# Bethesda Downtown Design Advisory Panel (DAP)

Project Name	4861 Battery Lane
File Number(s)	
Project Address	4861 Battery Lane

DAP SUBMISSION #2 SUMMARY  
4861 Battery Lane  
Oct. 11, 2023

June 28, 2023 DAP MEETING RESPONSE

## SECTION PERSPECTIVE RENDERING AT WESTERN FACADE

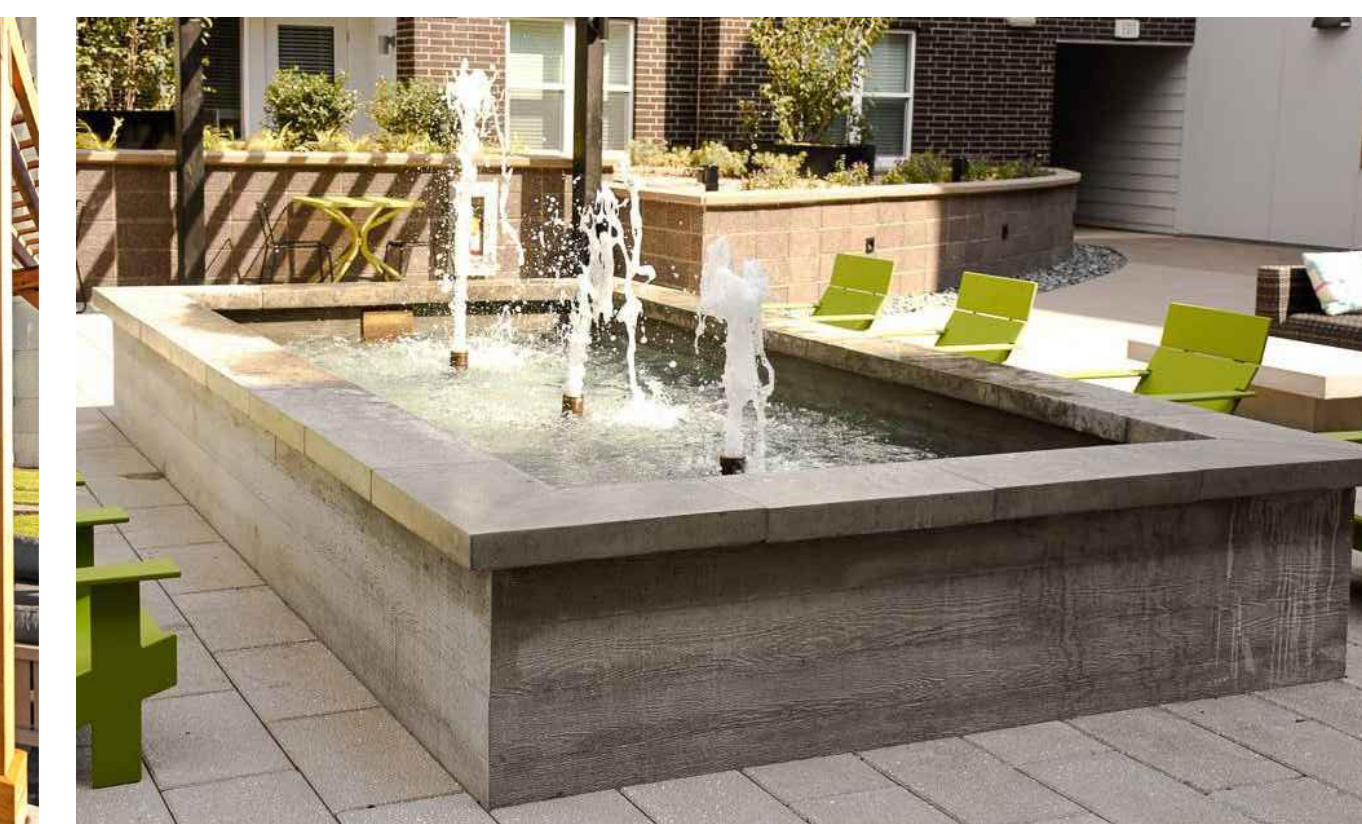
The bigger issue for me is the western side, how long is it, are the units accessible? I understand there is a grade differential	<i>Applicant Response:</i> The grade tapers as you go to the north side, the building drawings show patios with retaining walls that diminish and become ground level patio	Due to grading, it will be difficult to be accessible from the pathway.

I think the issue when you get to the next stage is, what is the articulation of that façade? It is very long and has not been given focus so far.		Western Façade has been further developed. A major vertical break in massing has been established at the 1/3 - 2/3 proportion. The break is further accentuated with a change in material and design language. Step backs are also present on this façade as the design language continues and wraps around to this facade from the front.
Staff: The length of the western property line is approximately 380 feet.		No Comment
One thing I saw that was peculiar with the submission was the canopy design, but with the rendering shown I begin to understand it.		No Comment
I’m looking at the size of the circular drop off and it is rather large given the neighboring property’s much smaller drop off footprint. Also having parallel parking seems completely unnecessary.	<i>Applicant Response:</i> They aren’t really parking spaces but more so delivery spaces. We’ve been working on these kind of buildings for quite some time. I understand the need for delivery spaces, but in the turnaround I do not understand. So, you are saying it is a benefit to having them park here as opposed to on Battery Lane?	Parallel Parking has been removed.

- Additional balconies added.
  - Western Façade
    - Major material and design language change at 1/3 : 2/3 proportion of the façade.
    - Step-back and articulation added for human scale.
